## SUBDIVISION AUTHORITY AGENDA MEETING NO. 27

RE: Tentative plan of subdivision to create 22 single detached residential lots, from Lot 4, Block 1, Plan 172 3270 located south of Hiller Road SW and east of 182 Street SW; **KESWICK**

RE: Tentative plan of subdivision to create one (1) additional single detached residential lot from Lots 23 and 24, Block 2, Plan 2630 KS, located north of 91 Avenue NW and west of Valleyview Drive NW; **PARKVIEW**

RE: Tentative plan of subdivision to create separate titles for Lots 1 and 2, Block 2, Plan 3079 EO, located north of 109 Avenue NW and east of 74 Street NW; **VIRGINIA PARK**

SUBDIVISION CONDITIONS OF APPROVAL MAP

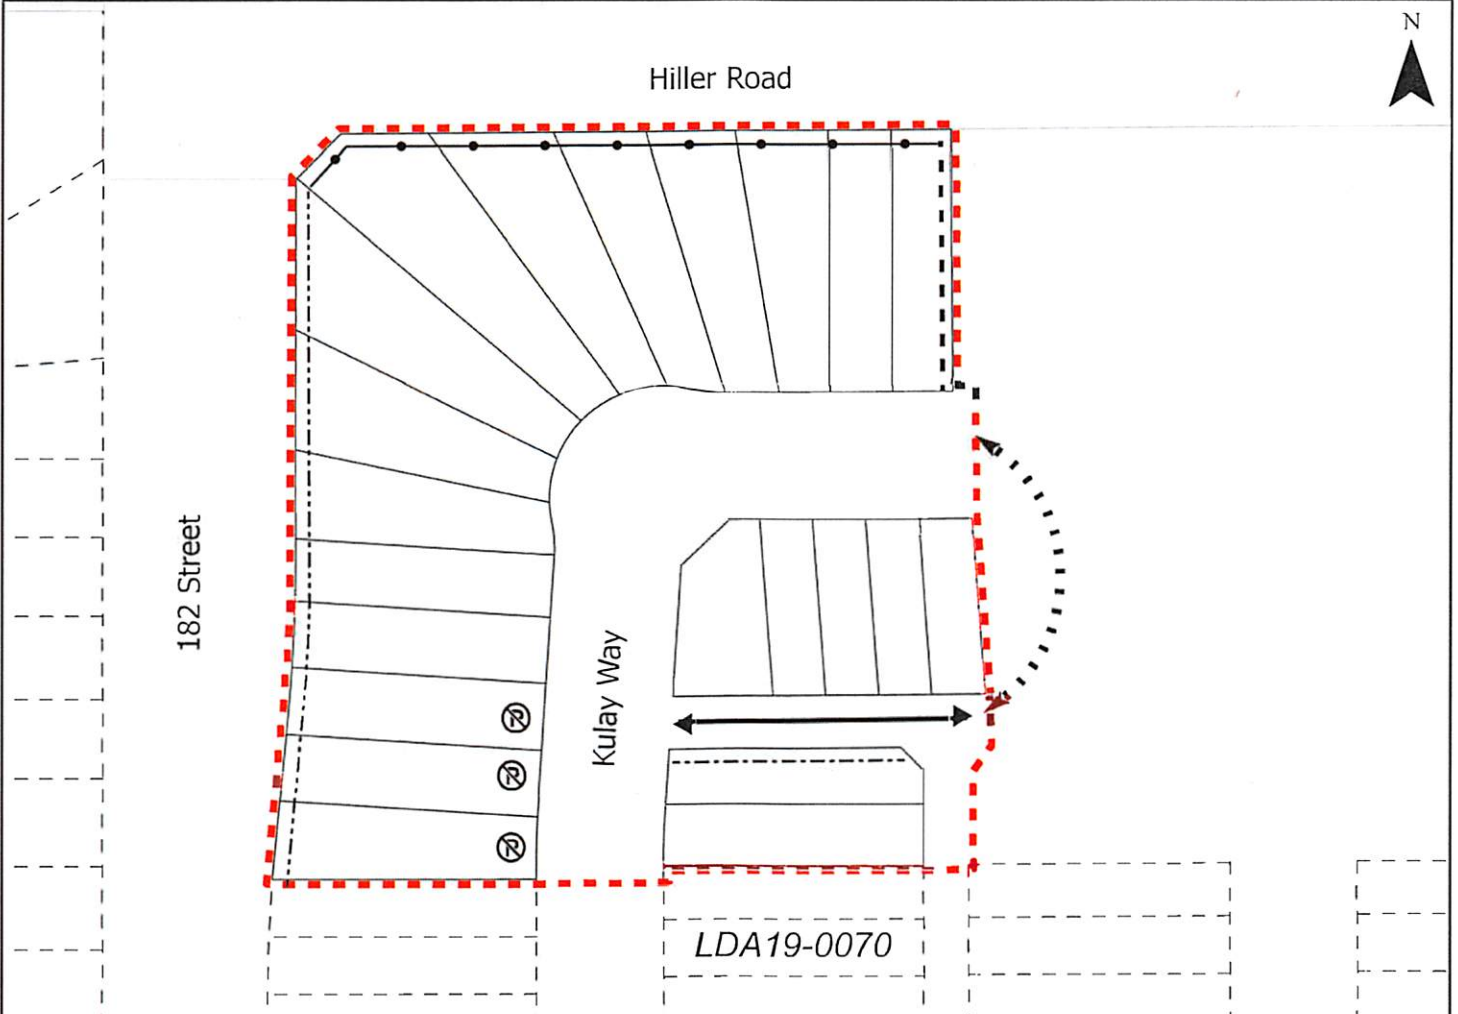
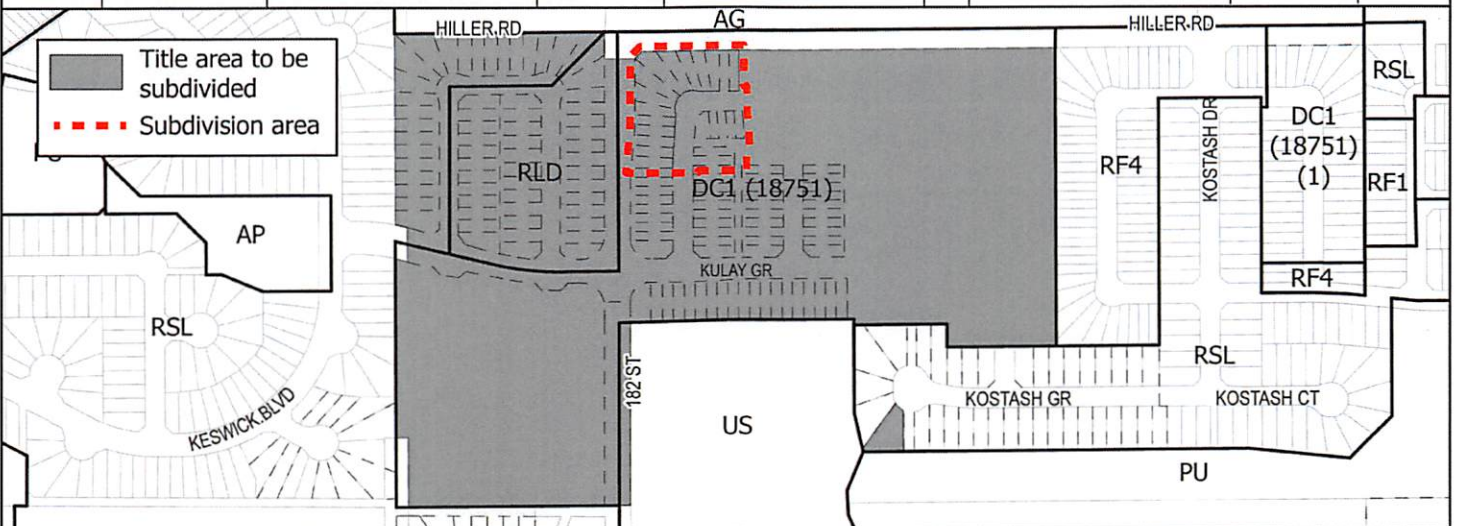
7. that the owner constructs a temporary 6 m gravel surface roadway connection to the satisfaction of Subdivision and Development Coordination, as shown on the "Conditions of Approval" map, Enclosure I. This roadway will be required prior to Construction Completion Certificate (CCC) for roads (or when required by Subdivision and Development Coordination);

8. that the owner construct an enhanced 7.0 m commercial alley and crossing, paved from property line to property line, to the satisfaction of Subdivision and Development Coordination, as shown on the "Conditions of Approval" map, Enclosure I. A swept path analysis is required to be submitted with engineering drawings to finalize Complete Streets design and cross-section details;

9. that the owner pays for the installation of "no parking" signage on Kulay Way SW, to the satisfaction of Subdivision and Development Coordination, as shown on the "Conditions of Approval" map, Enclosure I;

10. that the owner construct a noise attenuation fence contained wholly within private property for all lots backing onto Hiller Road SW, to the satisfaction of Subdivision and Development Coordination, as shown on the "Conditions of Approval" map, Enclosure I;

11. that the owner construct all fences wholly on privately-owned lands, to the satisfaction of Subdivision and Development Coordination, as shown on the "Conditions of Approval" map, Enclosure I; and

TENTATIVE PLAN SHOWING PROPOSED  
**SUBDIVISION**

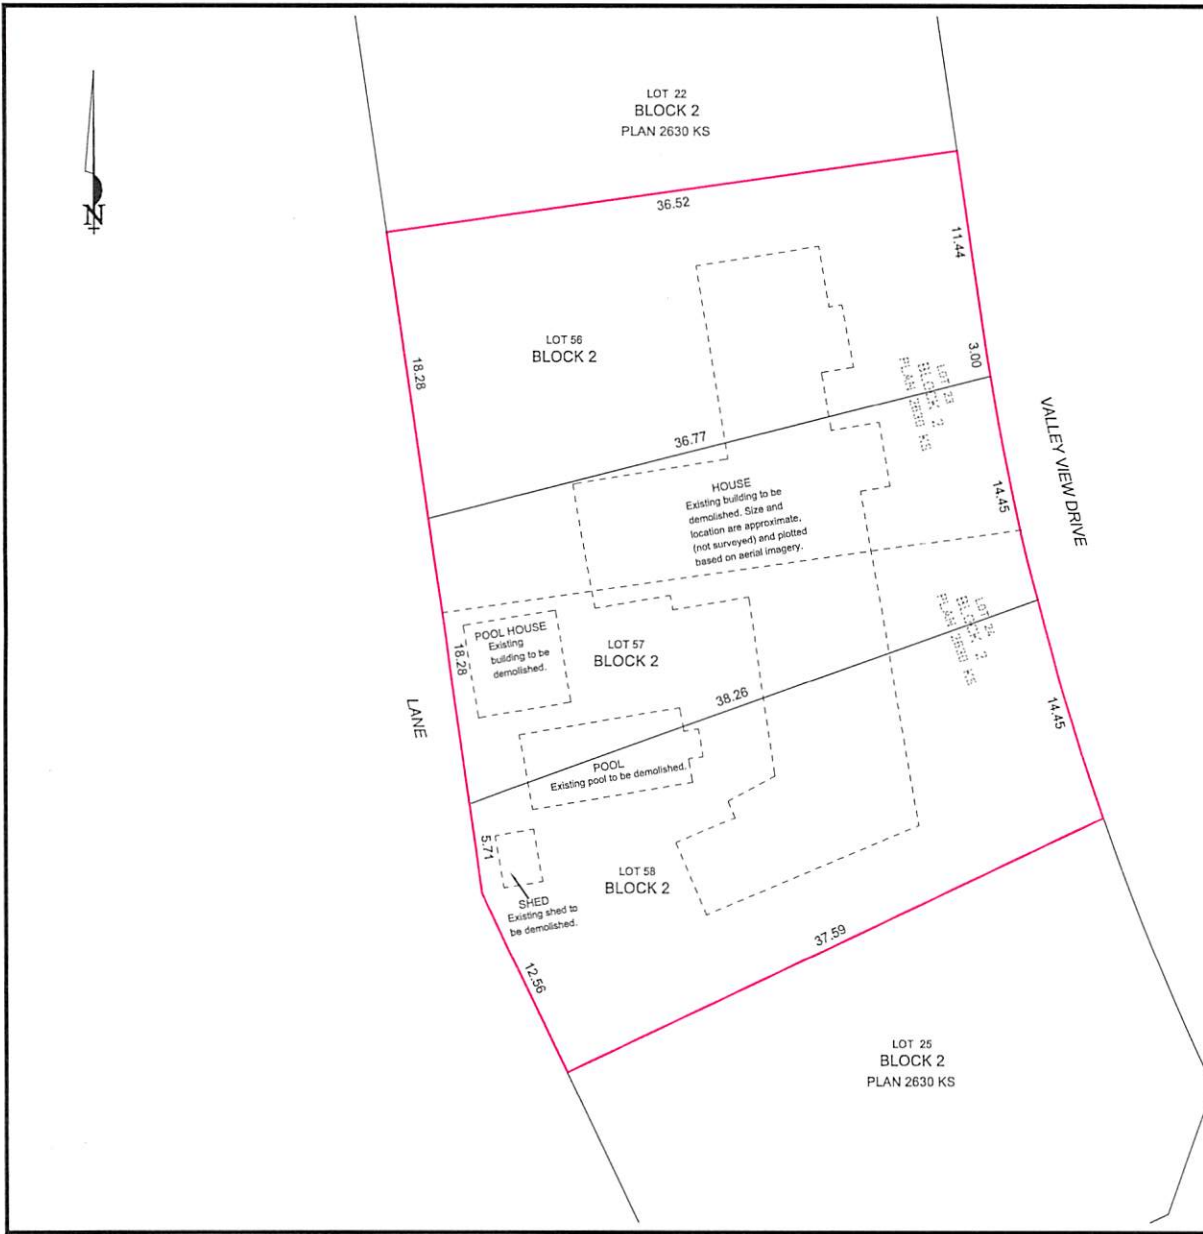
1. that, due to the unknown location of the storm services, the owner's surveyor will be required to provide a drawing of the existing services based on a utility locate of the storm services at the property line. Subsequent to that measurement, the property line shall either be deflected or the storm services shall be relocated;
2. that the owner apply for a permit to demolish the existing dwelling prior to endorsement of the final plan. Demolition permits can be obtained from Development Services. Apply online at [www.edmonton.ca/permits](http://www.edmonton.ca/permits); and
3. that the owner pay all outstanding property taxes prior to the endorsement of the plan of survey.

- Access for future development must be to the adjacent alley in conformance with Mature Neighbourhood Overlay Section 814.3(17) of the Zoning Bylaw #12800.

- There is an existing access to Valleyview Drive NW. Upon redevelopment of proposed Lot 56, the existing residential access to Valleyview Drive NW must be removed. The owner/applicant will be required to obtain a Permit to remove the access, available from Development & Zoning Services, 2nd Floor, 10111 – 104 Avenue. Apply online at [www.edmonton.ca/permits](http://www.edmonton.ca/permits).

- There are existing power poles in the alley. Site access must maintain a minimum clearance of 1 m from the closest edge of the power pole to the closest edge of the proposed driveway.

- There are existing concrete stairs that encroach onto the Valleyview Drive NW road right-of-way that must be removed with future redevelopment of the site. Permanent objects are not permitted to encroach within road right-of-way without entering into an Encroachment Agreement with the City of Edmonton. Email [encroachmentagreements@edmonton.ca](mailto:encroachmentagreements@edmonton.ca) for information on Encroachment Agreements

- The existing services (water and sanitary) enter the proposed subdivision approximately 18.9 m south of the north property line of existing Lot 23 off of the lane. There are two existing storm services that enter the proposed subdivision at unknown locations. As per the EPCOR Drainage Services Bylaw and the EPCOR Water Services and Wastewater Treatment Bylaw, these services cannot cross the proposed property line.

- There is a deficiency in on-street hydrant spacing adjacent to the property. The applicant/owner is advised to review on-site fire protection requirements to ensure adequate coverage (contact EPCOR Water at 780-412-3955).

Tentative plan showing Proposed Subdivision

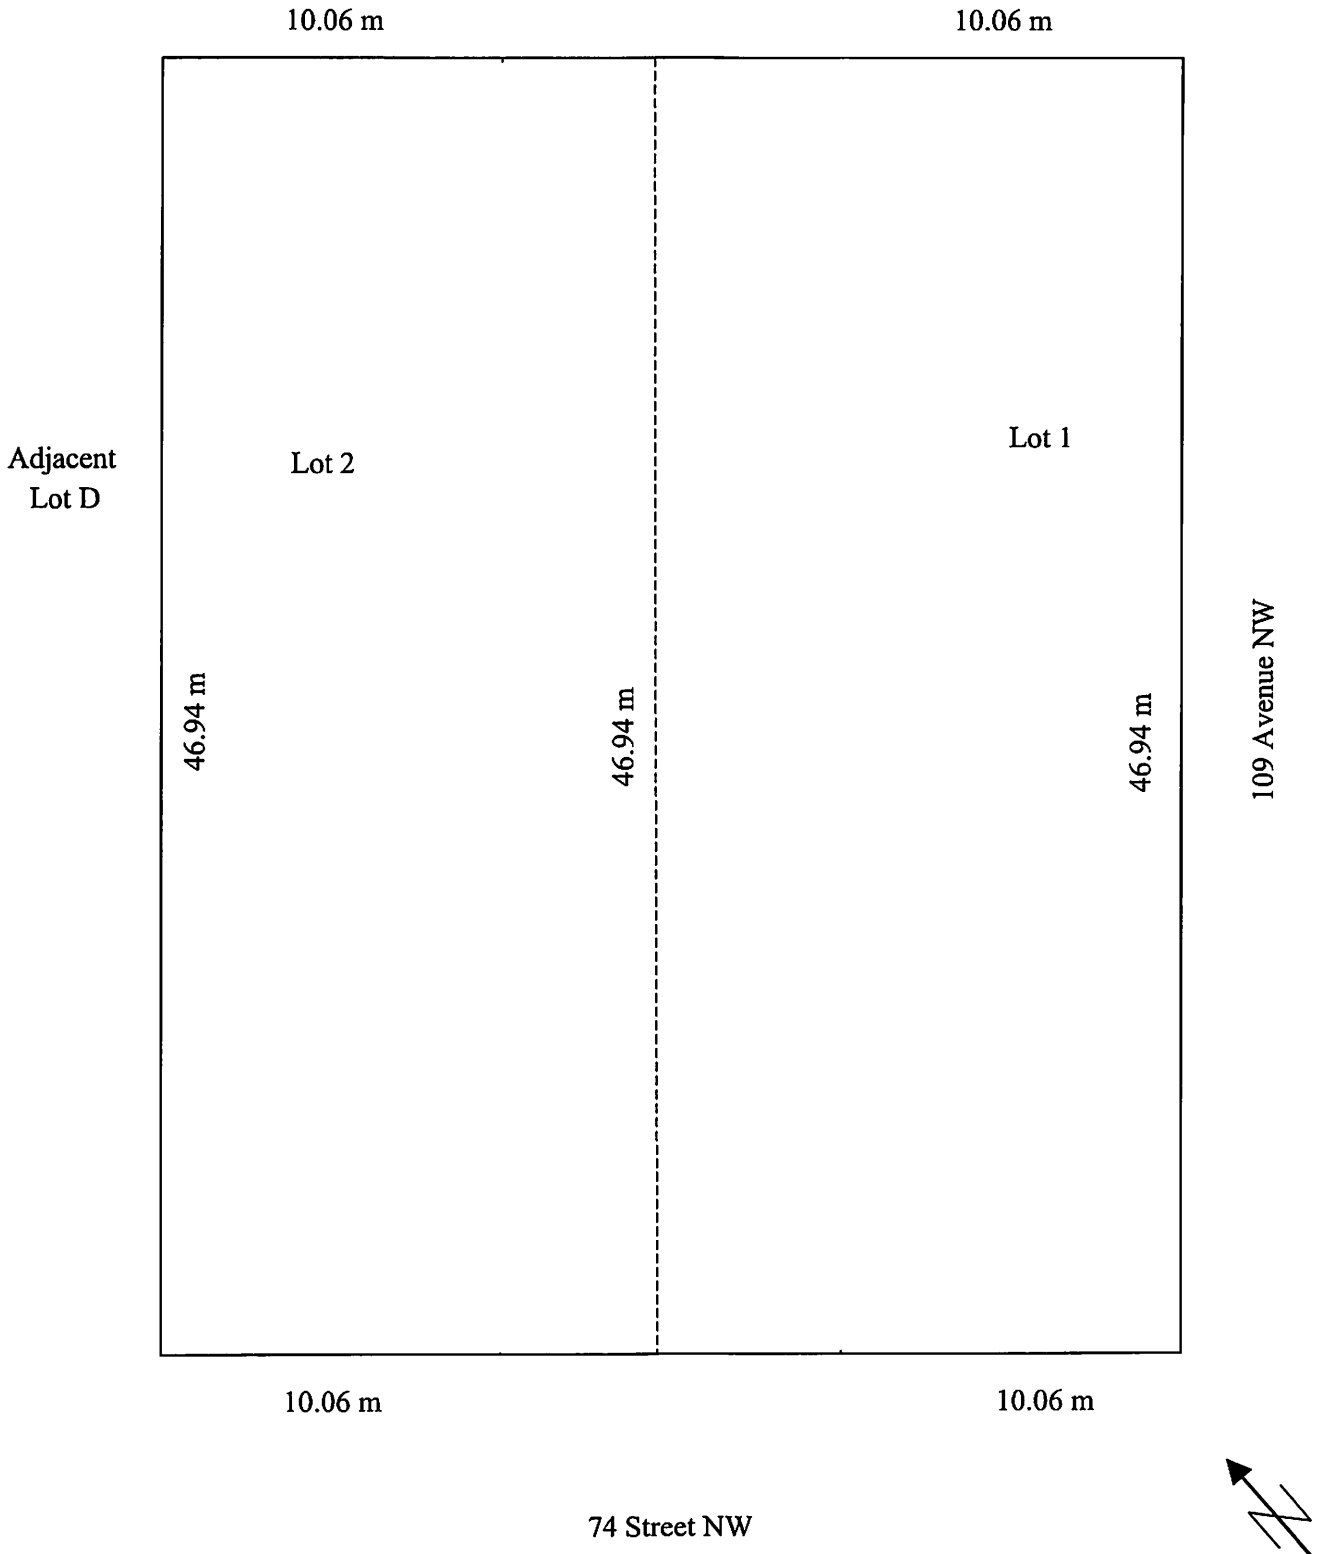
- There are existing boulevard trees adjacent to the site on 74 Street and 109 Avenue NW that must be protected during construction. For information about tree protection please refer to the City of Edmonton's website (search "Trees and Construction").

- Access to 74 Street from proposed Lots 1 and 2 must maintain a minimum clearance of 2.4 m from all boulevard trees. Prior to construction, the owner/applicant must contact to arrange for hoarding and/or root cutting. All costs shall be borne by the owner/applicant. Please contact City Operations, Parks and Roadways (citytrees@edmonton.ca). Further access details will be reviewed upon submission of a detailed site plan or Development Permit application.

- Access to 74 Street from the proposed lots may be challenging given the location of the existing boulevard trees and the existing surface utilities (ie: street light pole), as minimum clearances must be maintained. The owner is advised that future access to 74 Street may be very narrow.

- There is an existing concrete pad and other materials (temporary fencing, lighting, planters, etc.) that encroach onto the 109 Avenue road right-of-way that must be removed with future redevelopment of the site. Permanent objects are not permitted to encroach within road right-of-way without entering into an Encroachment Agreement with the City of Edmonton (e-mail encroachmentagreements@edmonton.ca for information).

- The existing water service enters the proposed subdivision approximately 4.11 m north of the south property line of Lots 1-2 off of 74 Street. The existing sewer service enters the proposed subdivision approximately 26.1 m east of Manhole #270019 off of 109 Avenue NW. As per the EPCOR Drainage Services Bylaw and the EPCOR Water Services and Wastewater Treatment Bylaw, these services cannot cross the proposed property line.
